City of Ryde Submission

**Key Site 6 Mixed Use Development
SSD-79017211**

2-4 Giffnock Avenue

Submission Date: 17 December 2025

Figure 2: Mark up of Ground Plan(Base Source: Studio.SC)

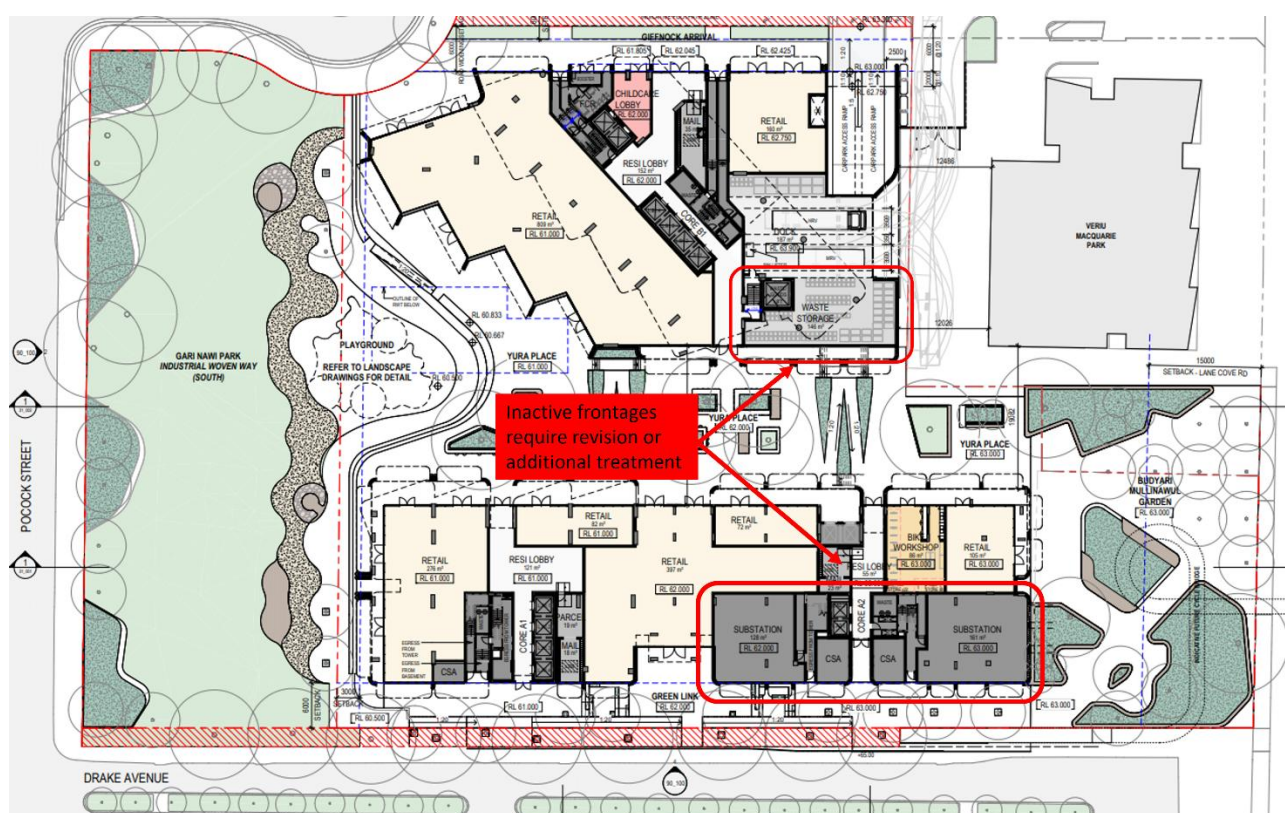
The proposed location and configuration of the substation at the eastern end of Tower B adversely impact the activated frontage, while the proposed waste storage for Tower A creates an inactive blank wall along the Yura Place as a major public domain and through-site link within the development.

Figure 2 demonstrates these inactive frontages. The proposed substation facing Drake Ave and the future active transport link (left), and the proposed waste storage facing Yura Place (right). Council notes that the Macquarie Park Design Guide requires “contributory frontages” facing drake avenue, for which the proposed substation does not assist in achieving, therefore further revision is recommended.

Figure 6: Mark up of Ground Level (Base Source: Studi.SC)

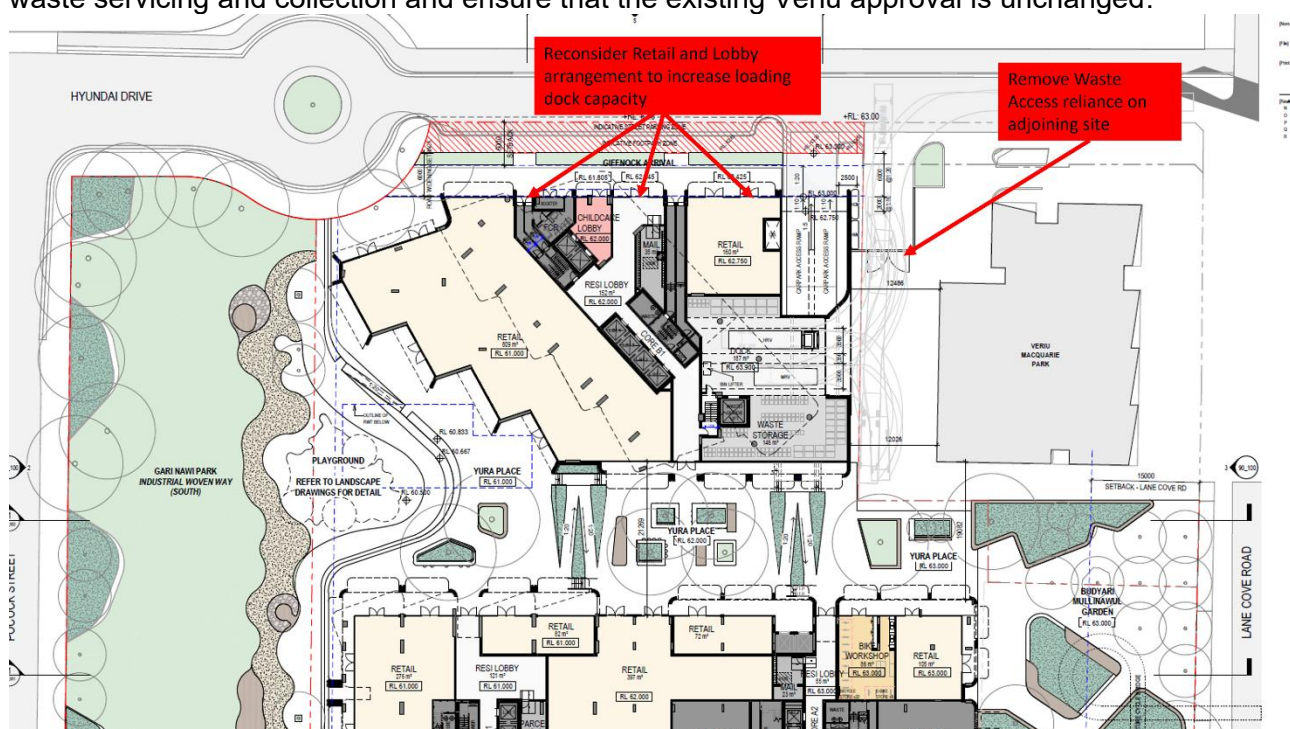
Council notes that the Veriu consents require that the area for which key site 6 will access, that the land be used for Landscaping and deep soil for the site. The proposed access will be reducing that sites required landscaping, reducing amenity and reducing tree canopy coverage that was required under Council's assessment of that application. It is recommended to reconsider loading dock access as shown in the below Figure 7.

- Revising their loading and access arrangement to occur directly from Hyundai Drive.
- The Applicant can relocate their retail/ commercial areas to other locations on the building (to still achieve compliance with LEP minimum commercial requirement), such as placing it in podiums (rather than solely on ground level).
- The applicant can reconsider residential/ childcare lobby as to not conflict with any future loading dock access points creating safety concerns (for residents and children).

By making the above design moves the applicant can positively increase loading bays, improve waste servicing and collection and ensure that the existing Veriu approval is unchanged.

Figure 7: Sketch showing potential amended design of pedestrian bridge (Base Source: Studio.SC)

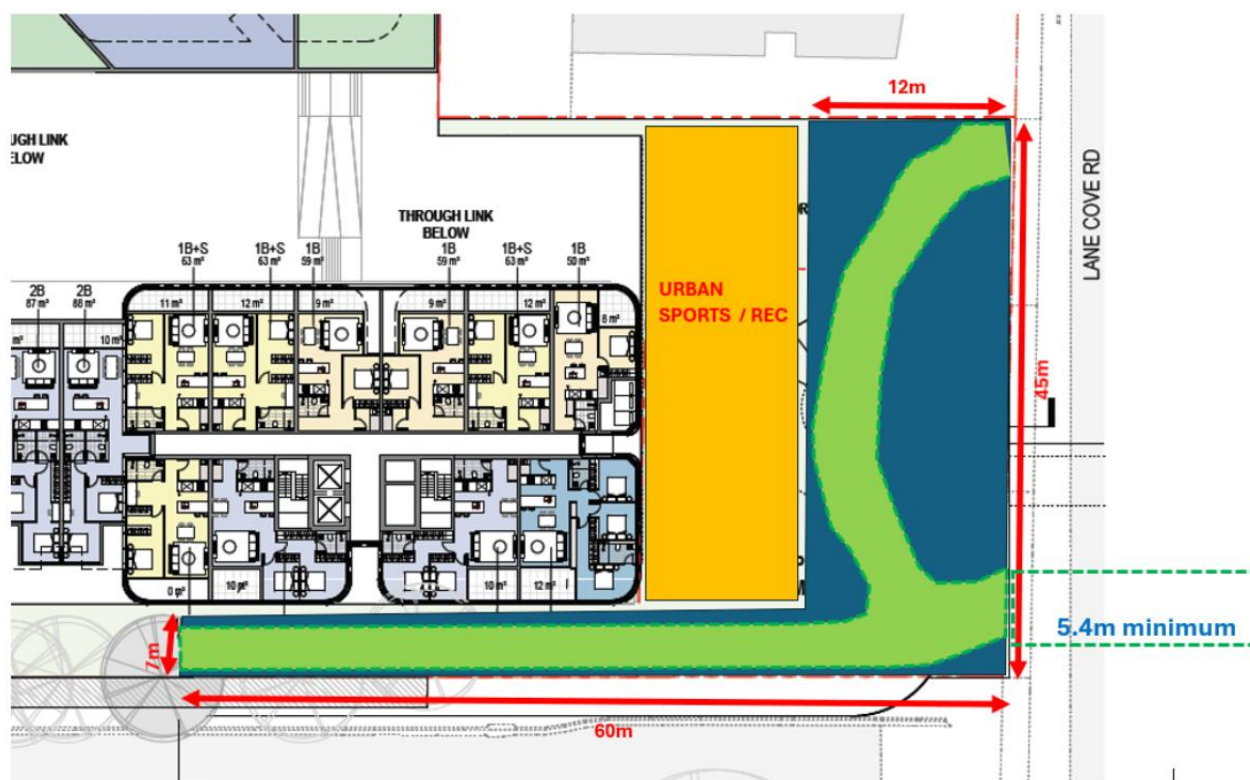
It is considered critical that the shape of the lot on which the future pedestrian bridge landing sits in Key site 6 is amended from the current square shaped lot / spiral alignment to a shape which would provide more adequate connectivity to the and from the metro station. It is requested that further consultation with TfNSW is carried out to support an amended shape of the land dedication, to enable better pedestrian connectivity outcomes when the bridge is finally constructed.

The current rectangular shaped dedication is unlikely to support an extended landing ramp adjacent to Drake Avenue as it has to extend beyond the rectangular shaped area and would prevent optimal connectivity between the site and the Metro station. In summary Council has concern that the current land geometry as shown may prevent optimal future connectivity being achieved by the pedestrian bridge and as such Council may be stuck with a lot of land which cannot be utilised appropriately for its intended purpose. At a minimum it is expected that consultation with TfNSW progress to in principle endorsement of a concept plan which details arrangement and ramp levels which will guide land dedication shape. An example of an L-shaped dedication is shown below:

Figure 8: Mark up of Design Guide Street Location (Base Source: Macquarie Park Design Guide)

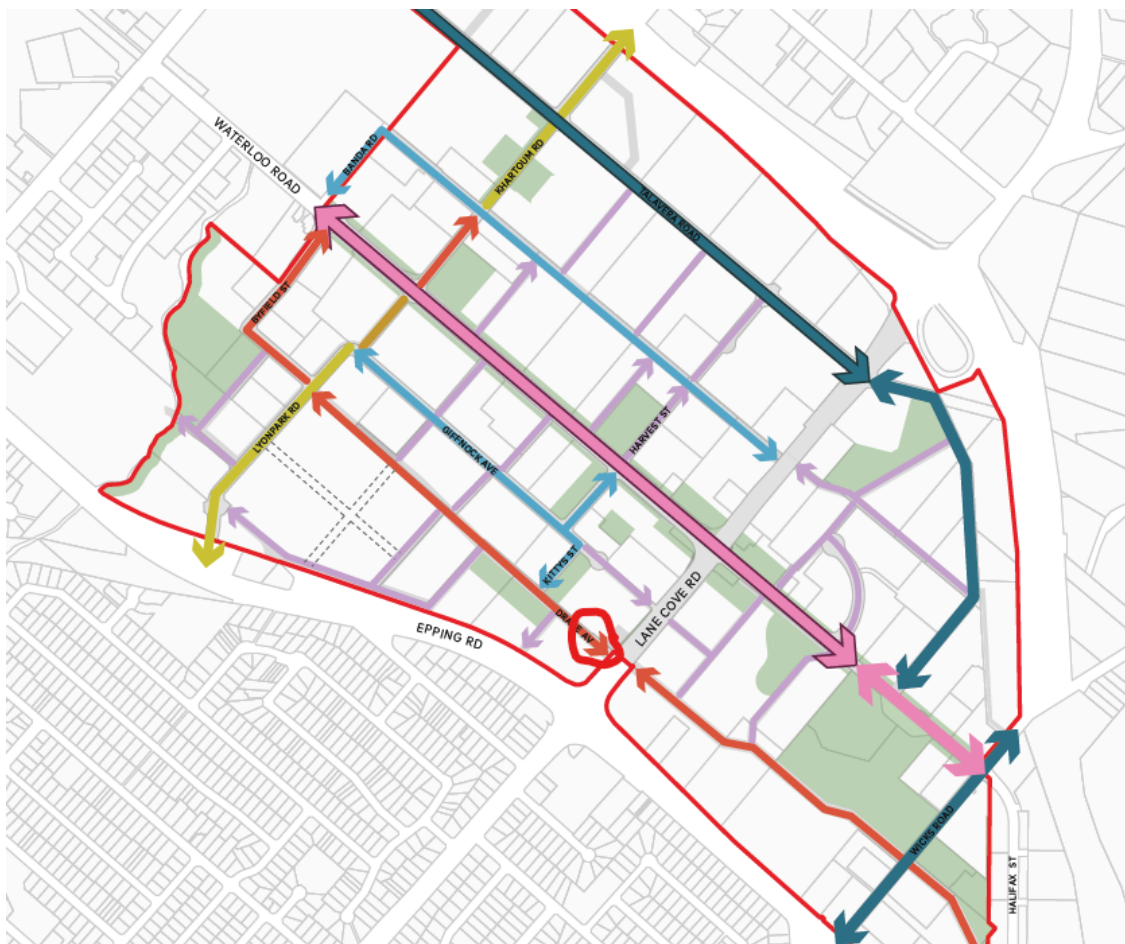
The Updated Macquarie Park Design Guide issued DPHI in November 2024, specifies an intention for Drake Avenue to provide direct vehicular access to Lane Cove Road. In general, an arrow from a local road to an existing road, denotes an intention to provide a vehicular connection (Figure 7). Drake Avenue is to be upgraded and dedicated as part of the future development of Key Site 5 which neighbours the subject development site.

To achieve vehicular connection between Drake Street and Lane Cove Road, would require the significant raising of the Drake Street Road reserve, which already sits above the subject site. If Drake Street were to be raised locally in the future within the vicinity of the Lane Cove Road intersection, this would significantly affect the boundary interface with the subject development site.

Clarity should be obtained through consultation with TfNSW, on whether there is an intention to provide a vehicular connection at the Lane Cove / Drake Avenue intersection so that an appropriate interface can be designed, significant level differences between building entrances and the future Drake Avenue Road reserve.

Figure 9: Extract from Stormwater Plan

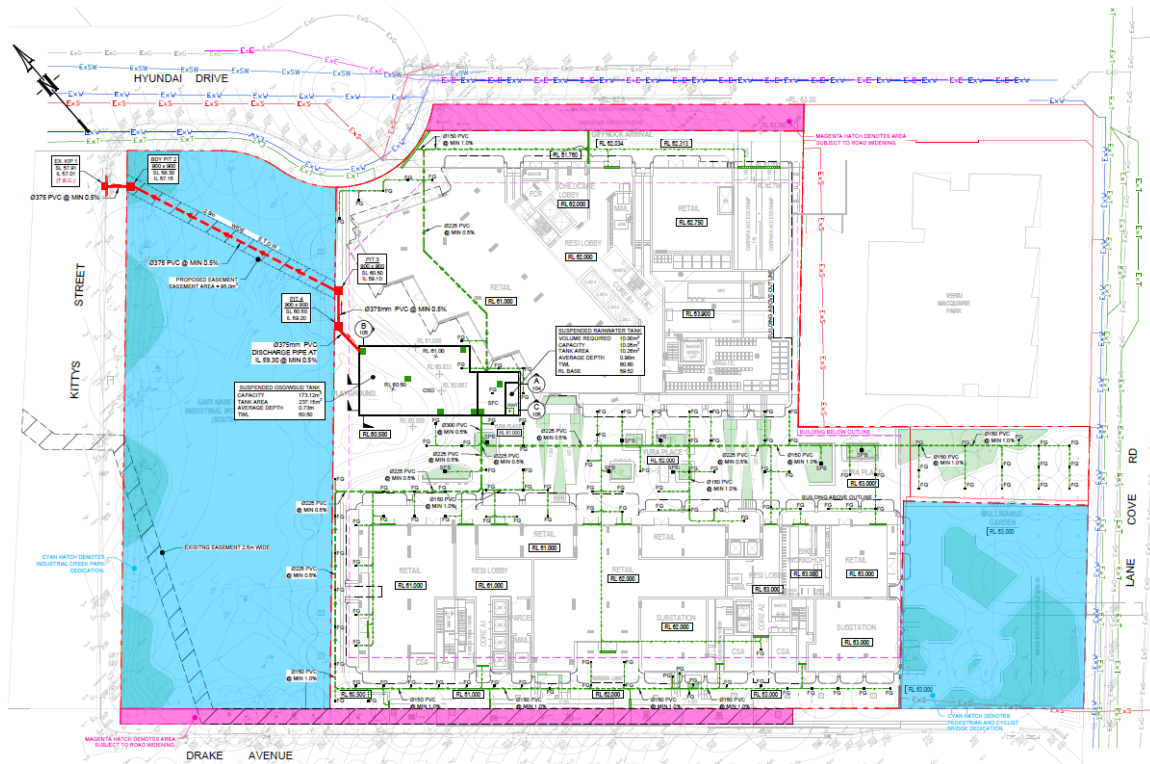
It appears that the proposed road widening works have not accounted for the adjustment of existing Council drainage infrastructure. Accordingly, where public domain works are undertaken to widen Hyundai Drive and Drake Avenue, the existing stormwater drainage infrastructure including kerb inlet pits must be relocated or modified to suit the revised road alignment.

- Please clearly identify and annotate the ownership of all easements within your lot. Based on the available information, these easements service private developments and therefore must be maintained privately.
- If any private easements are proposed to be extinguished, please note them on the plan.

Please update the Civil plans to indicate the new alignment of the kerb and gutter and stormwater infrastructure under the kerb and gutter. The plan is also to be updated to reflect:

- The location, width, and depth of the proposed footpath must be shown, along with the stormwater outlet passing beneath it clearly indicated on the stormwater plan.

- Kerb and gutter alignment to be shown.
- Please indicate cover depths and pipe classes under the footpath.
- Please provide a drainage network capacity assessment for the proposed connection(s) to Council's stormwater system. The assessment must confirm that the receiving network has adequate capacity to accommodate the development's discharge without causing surcharge or adverse downstream impacts.

- HGL is to be clearly indicated on the plans.
